SIB 11 10 21

RECALL 21V-907: EXHAUST GAS RECIRCULATION (EGR) COOLER – N57T LOW TEMPERATURE

This Service Information Bulletin (Revision 2) replaces SI B11 10 21 **dated February 2022**.

PROCEDURE 1: REPLACE THE EGR COOLER

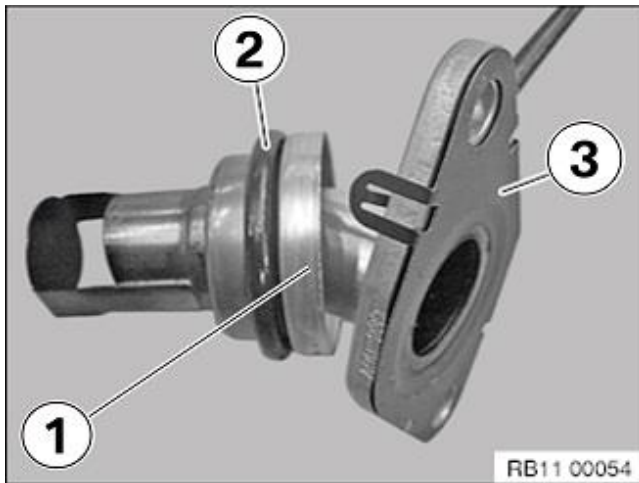
- When the old EGR cooler is removed:

- Remove the EGR pipe from the intake venturi pipe (replace O-ring (2) and gasket (3)).

- Inspect and clean (if needed) the EGR pipe. Wear protective equipment (eyes and hands) and clean out the excessive carbon using a degreasing agent and a brush (suitable brushes can be found in wheel brush kit 83 19 2 298 237).
- Reinstall the EGR pipe with new gasket and O-ring before installing the new EGR cooler.

- Replace the coolant pipe from the Auxiliary EGR cooler to the coolant pump distribution block (1)

- NOTE: The new coolant line PN 11 14 7 827 410 is routed in a different location than the original line (1)
